King's Daughters

KD-3123.0-26

GC Services for UK King's Daughters Medical Center – Greenup Co. Urgent Care/Family Care Medical Office Building

ADDENDUM # 02

2 FIRE PROTECTION DESIGN CRITERIA
SCALE: NONE

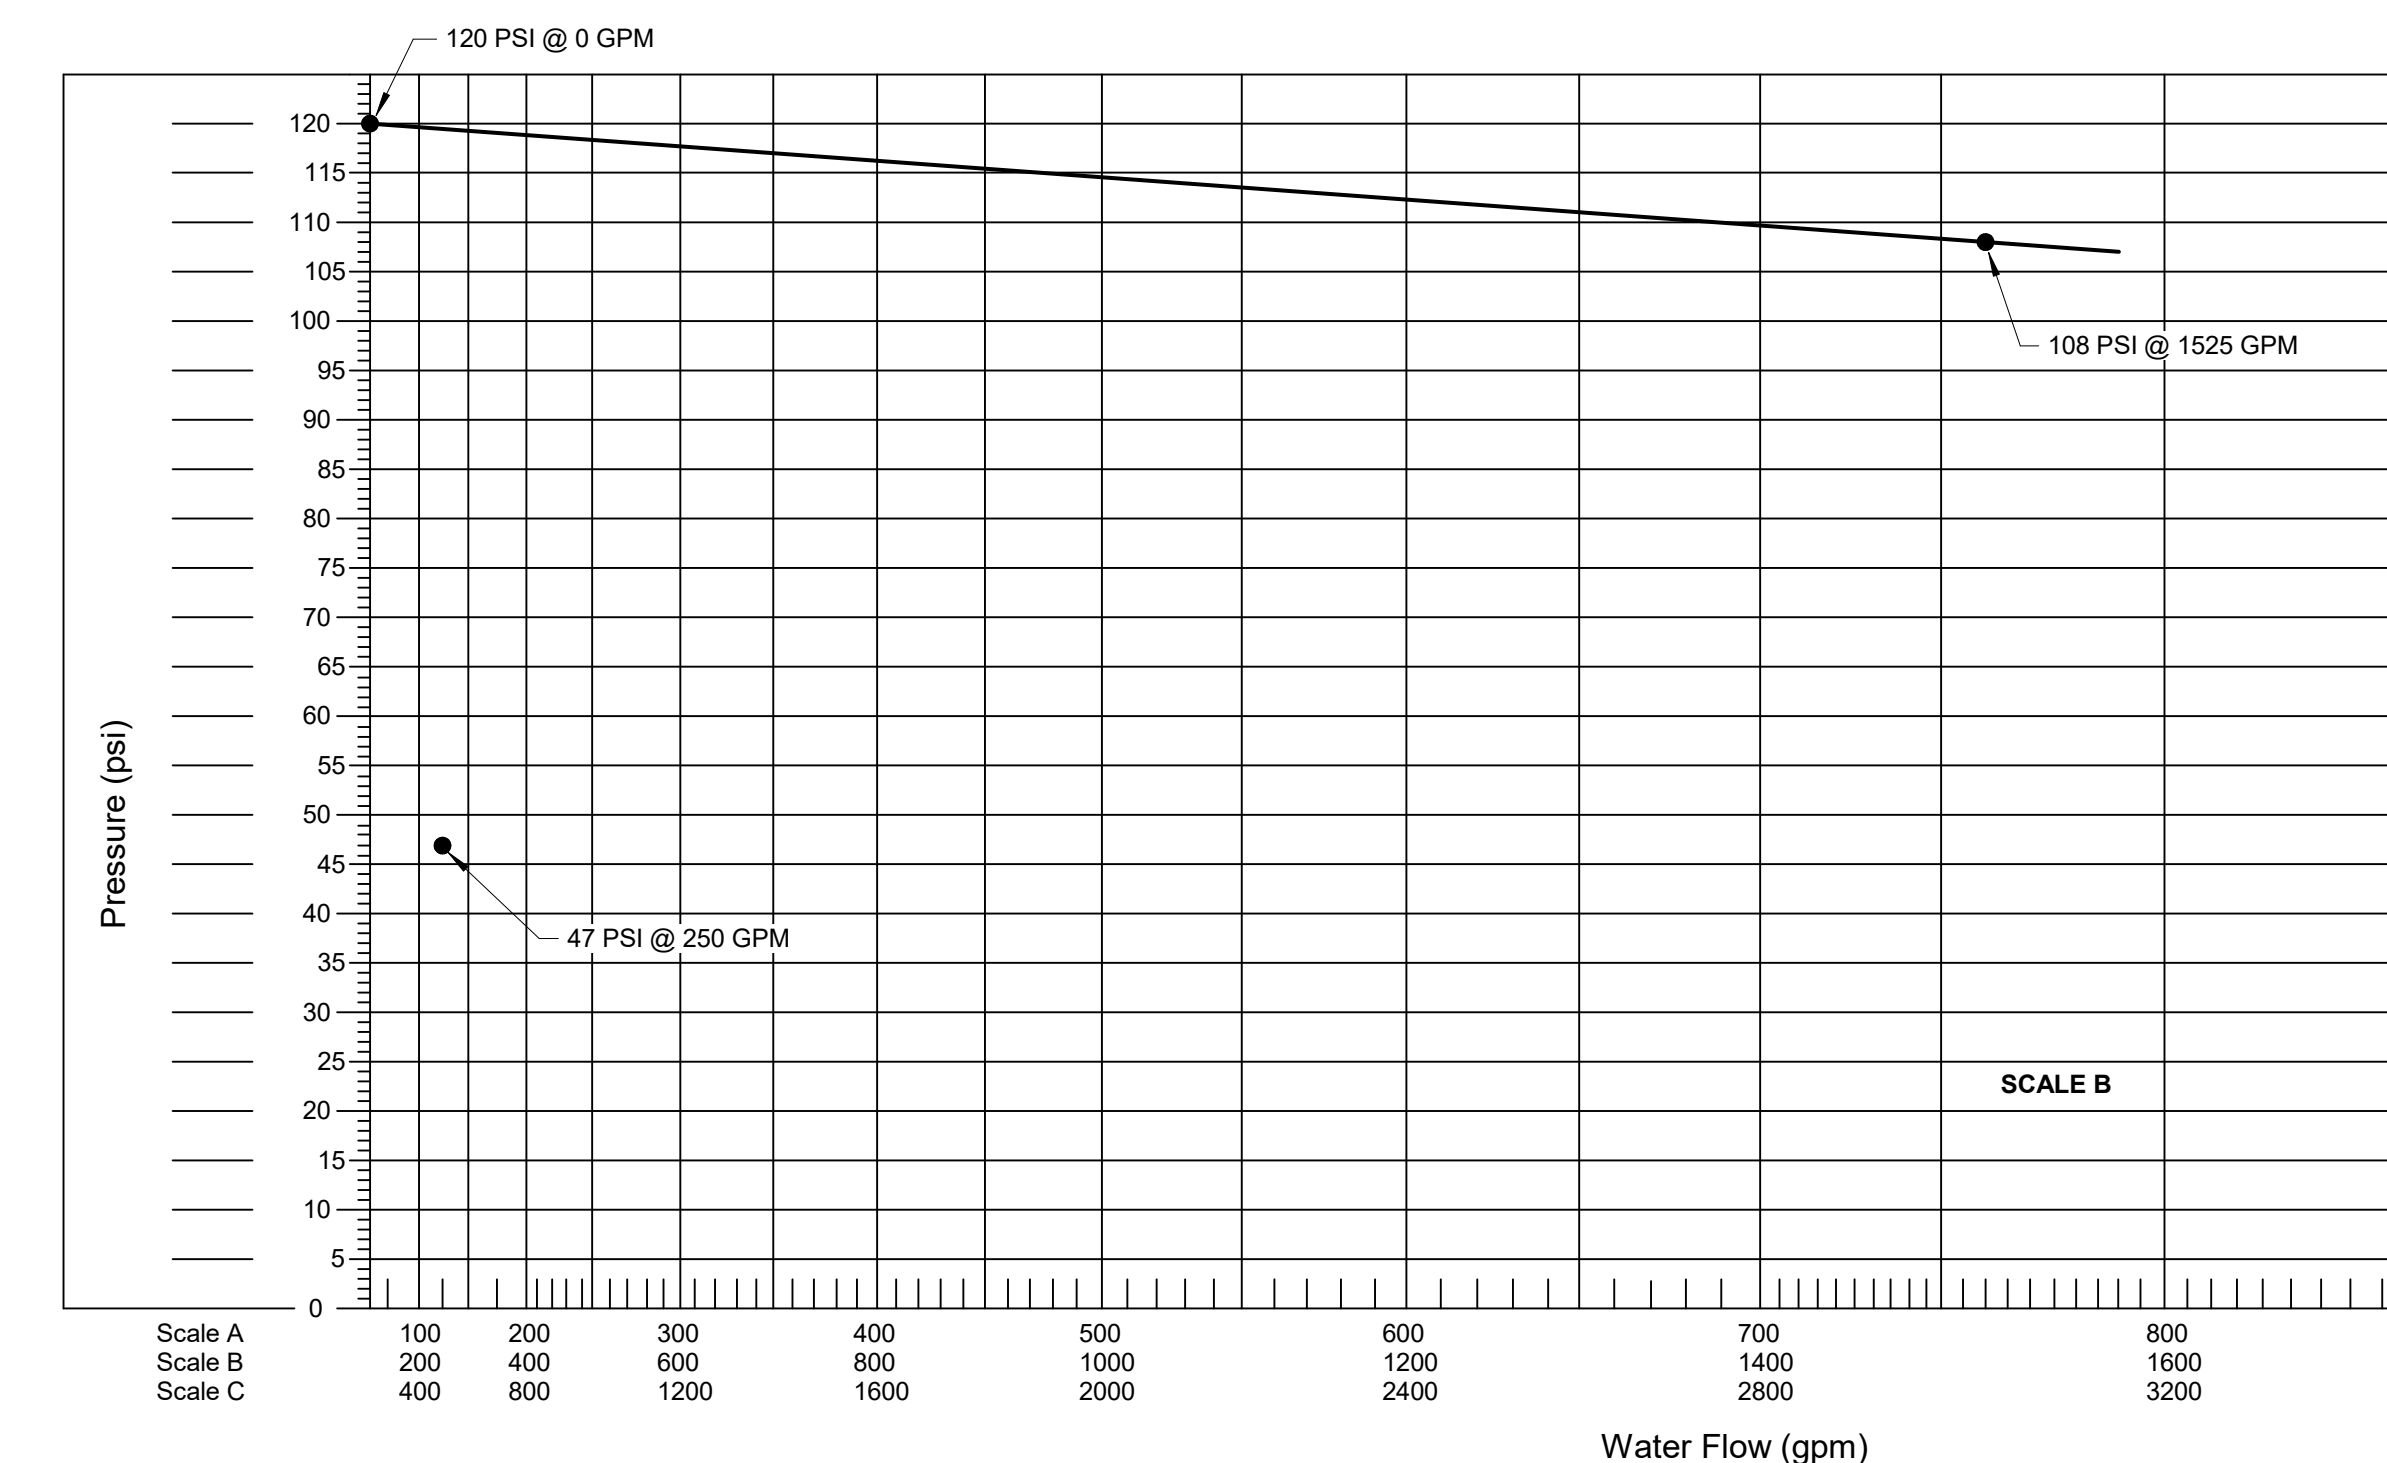
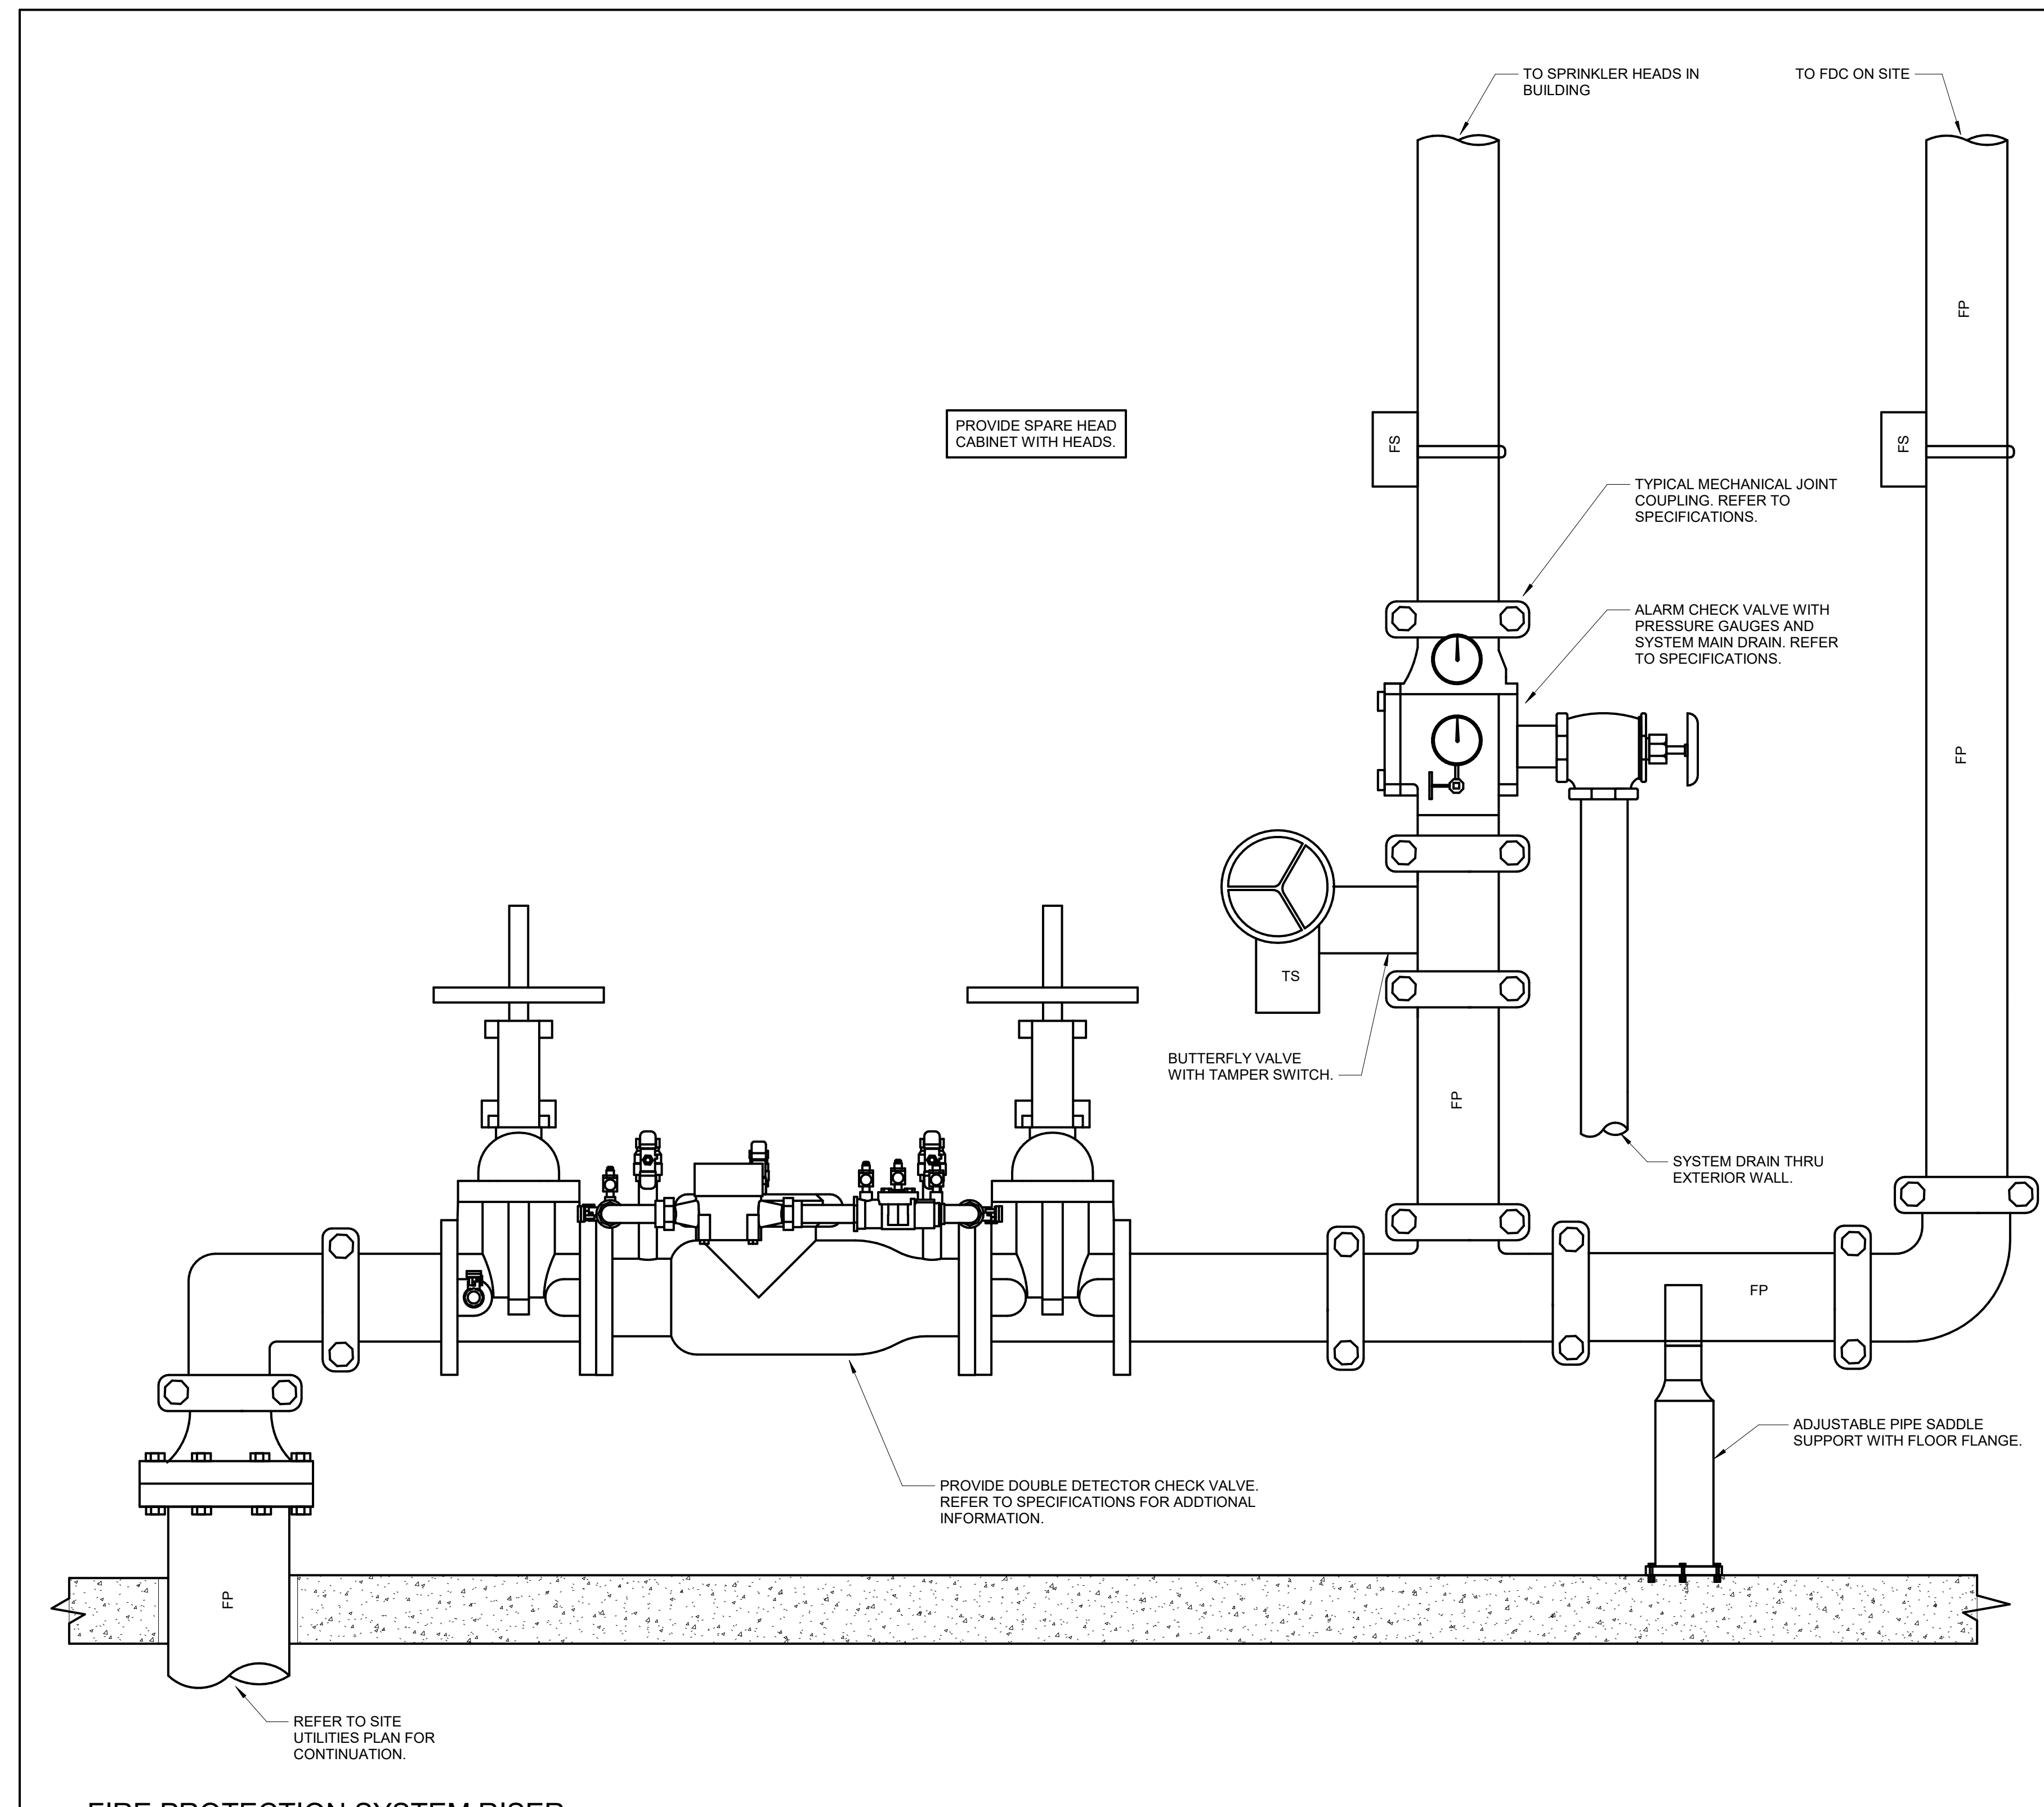
Refer to the attached revised Sheet F-200 Fire Protection Details/Calculations

EU-1
COPYRIGHT 2026 - JRA, INC.

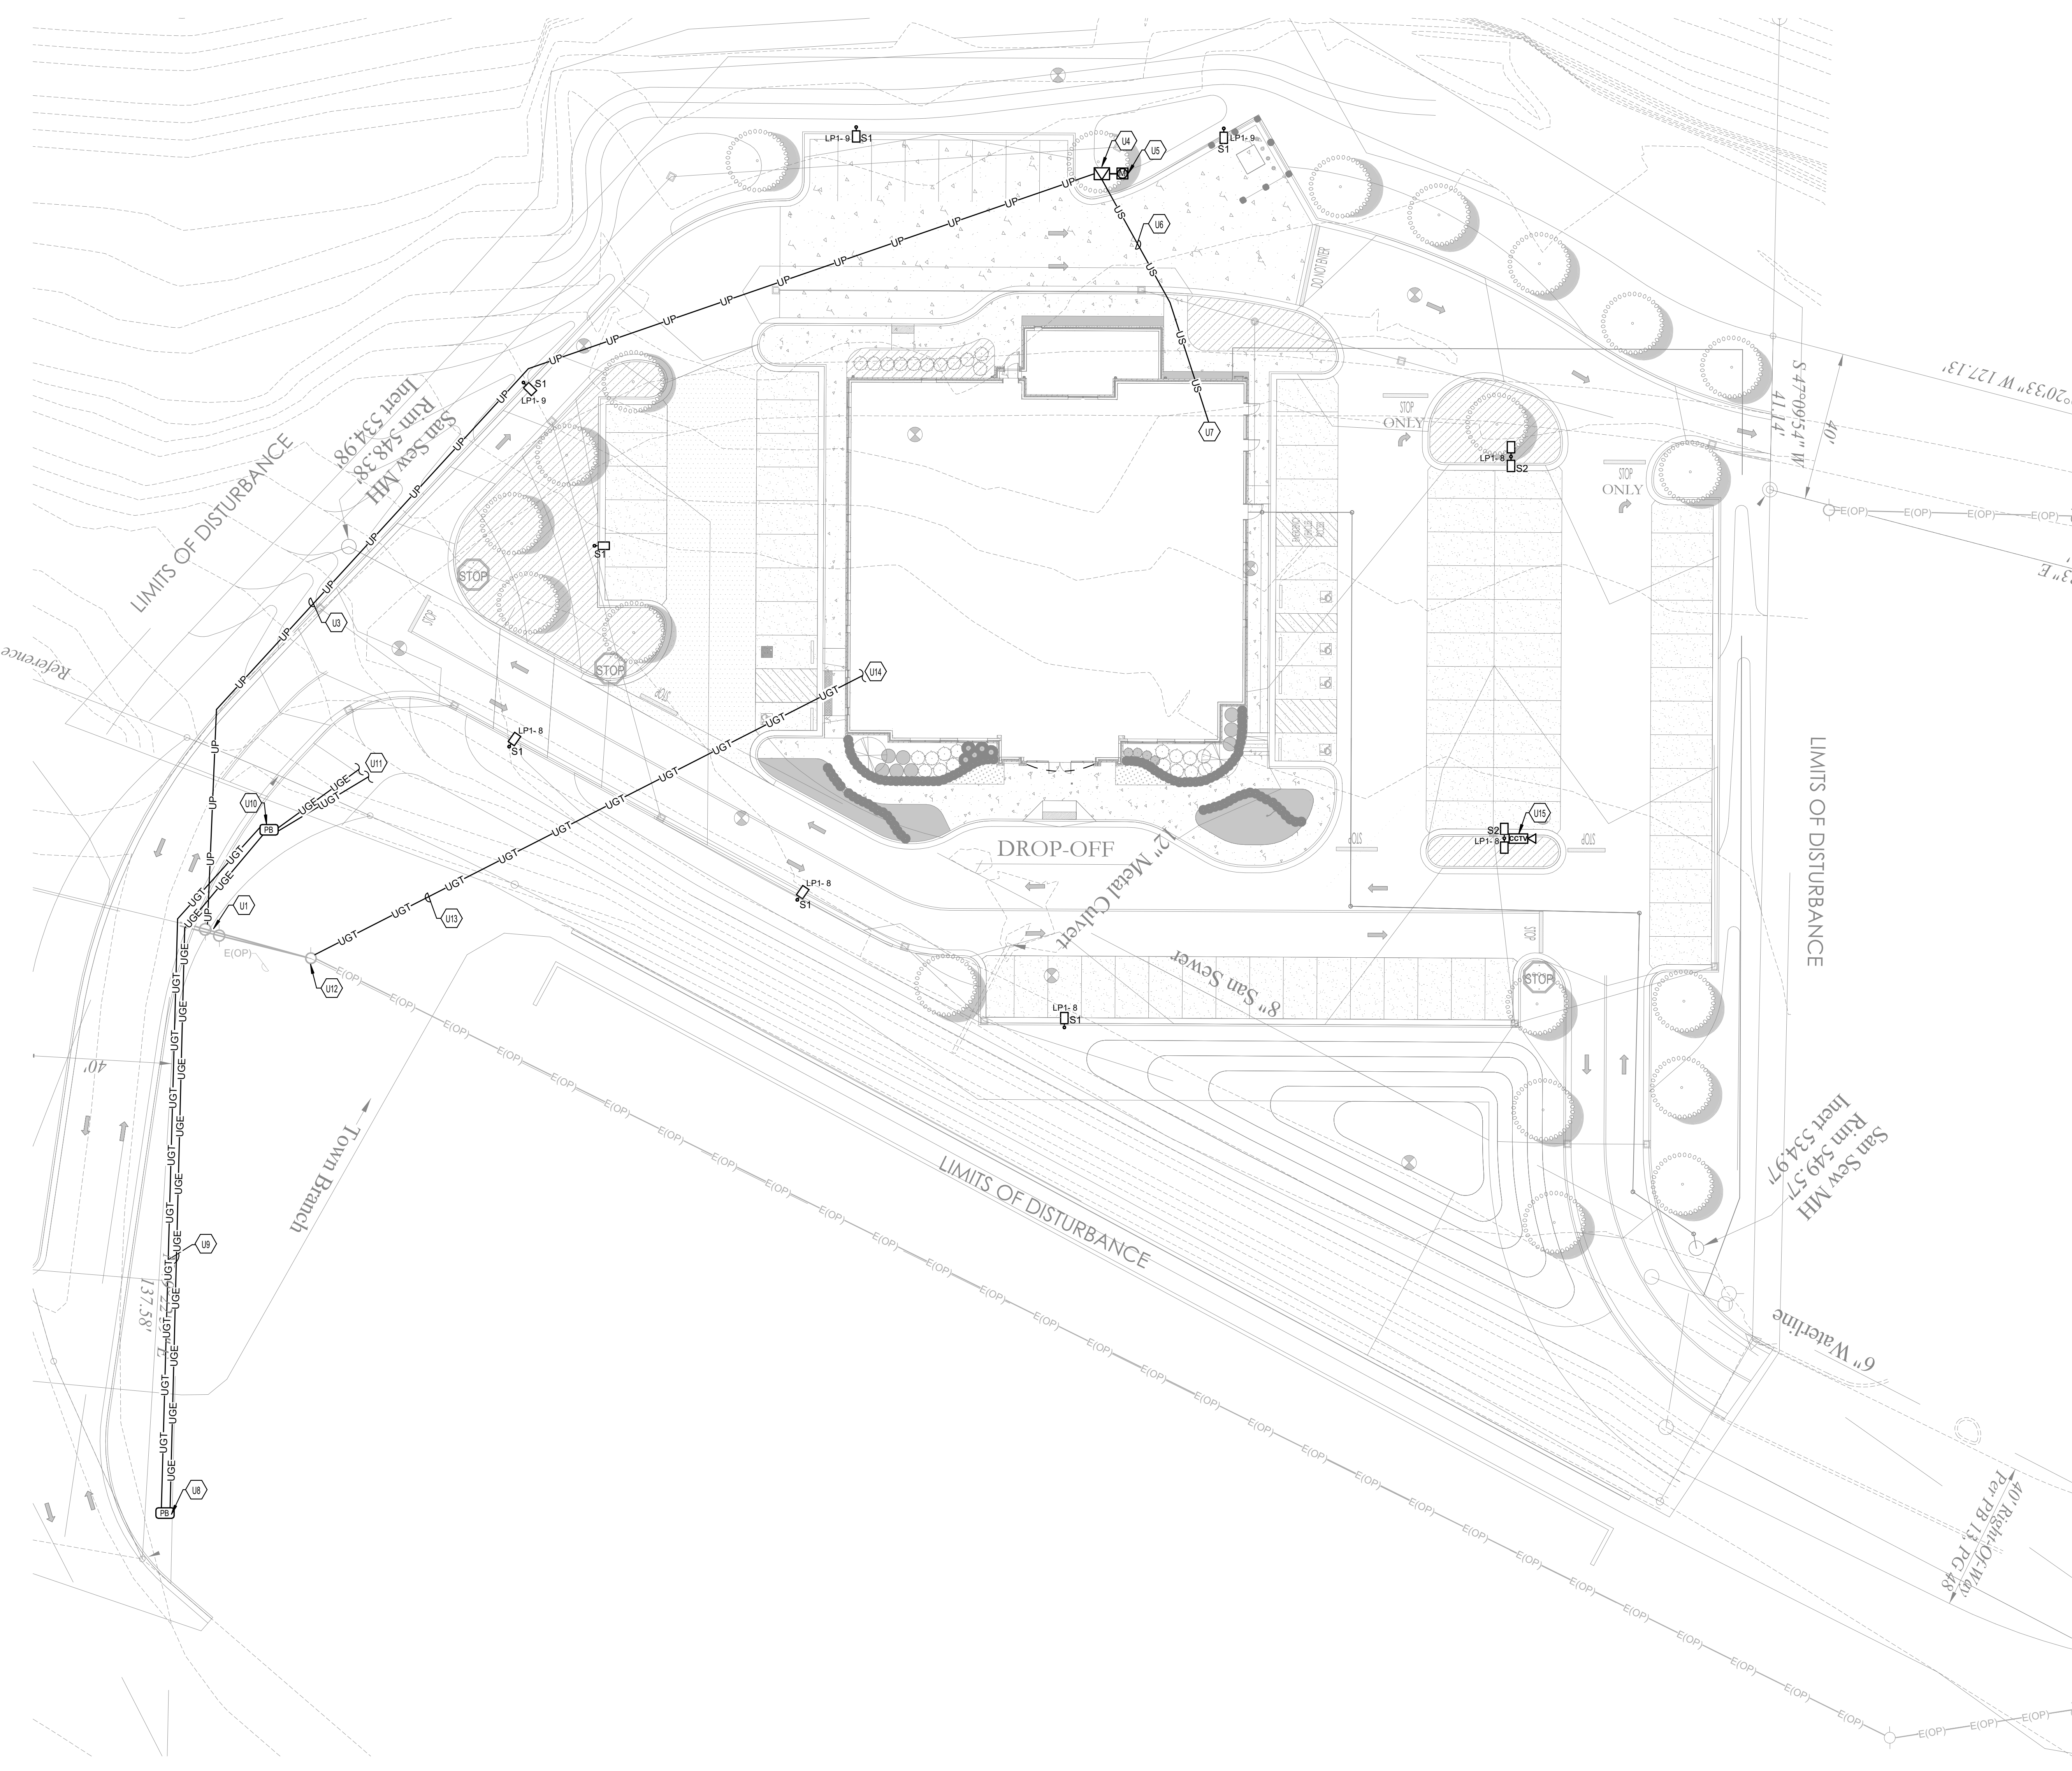
Refer to the Electrical Drawing – EU-1
